Product Change Notification

Change Notification #: 118553-00
Change Title: Select Intel® NUC Pro Chassis Element
CMCM2FB
Intel® NUC Pro Chassis Element
CMCM2FBAV
PCN 118553-00, Label, Product Marking
Change CB logo on rating label from UL to
NTRL
Date of Publication: October 08, 2021

Rating label with NTRL logo

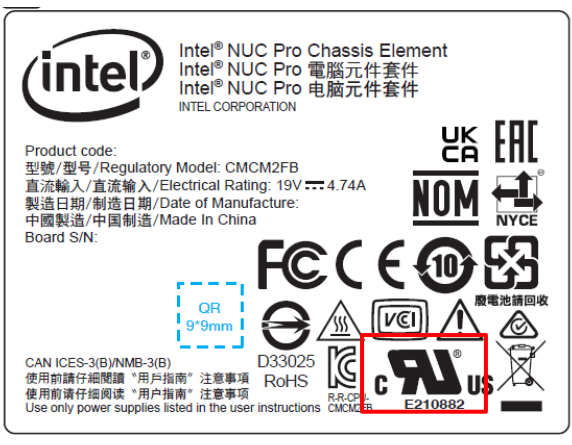
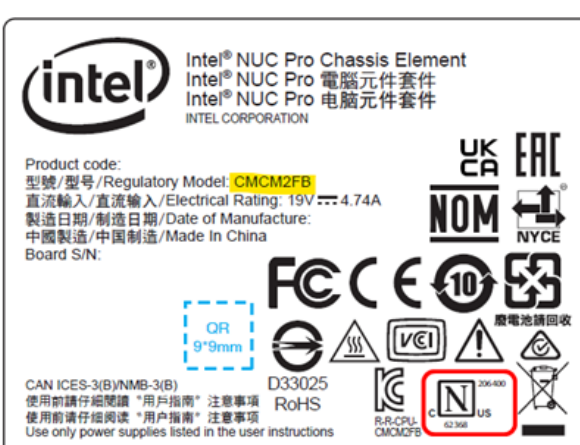
- Change CB logo on rating label from UL to NTRL due to Lab convert from UL CB to Nemko NRTL CB.
